## S5000 TECHNICAL BULLETIN 3

Date	5/1/2021
Topic	Shock Setup and Adjustment
Priority	Information

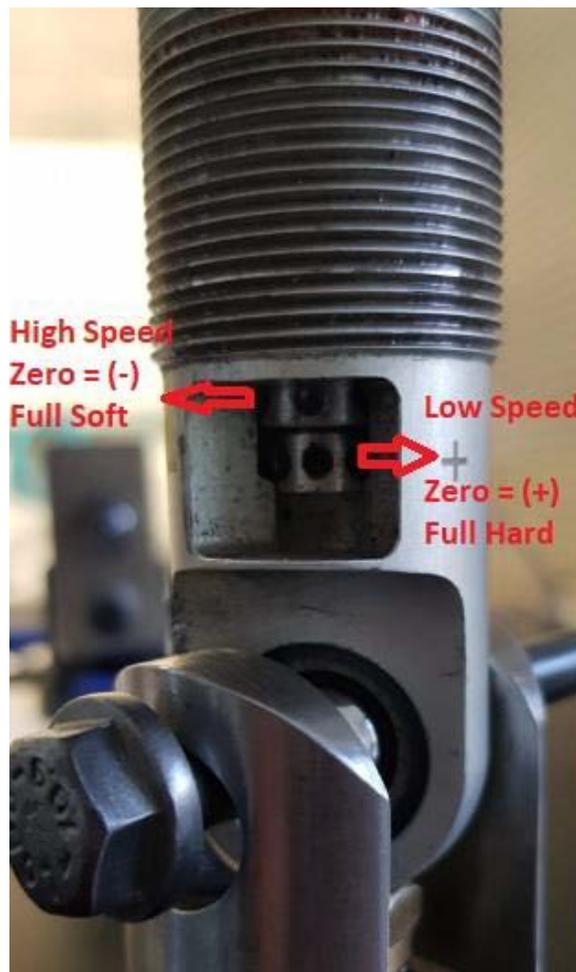
1. If excessive force is used on the shock rebound adjusters they jam, requiring servicing.
2. Update on general procedures on adjuster settings and gas pressure

The JRi shock comes with two adjustments for rebound. The larger adjuster is for high speed rebound, the smaller for low speed rebound.

When setting these adjusters, please use the JRi pin tool (GRM-CI0002-00) to not overtighten & jam the adjuster. These are designed to snap if forced too hard. The tool can be ground flat & re-used if the dowel pin remains with sufficient length. New pin tools are available to purchase.

High speed zero = full soft (adjuster all the way to the negative sign on the threaded eyelet. This is your zero setting).

High speed +10 = full hard (+10 sweeps from zero). **Do not start from full hard as zero as you will not get matching damping forces left to right. Do not try to force the adjuster any further than 10 sweeps or it will jam.**

Low speed zero = full hard (adjuster all the way to the positive sign on the threaded eyelet. If at this point the adjuster is not in a detent position, then rotate the adjuster back until it falls into the closest detent. This is your zero setting). **THE HSR ADJUSTER MUST NOT TURN WHEN YOU ADJUST THE LSR ADJUSTER. IF IT STARTS THEN YOU HAVE REACHED THE LSR ZERO POINT.**

Low speed -30 = full soft (-30 sweeps from zero). **Do not start from full soft as zero as you will not get matching damping forces left to right.**
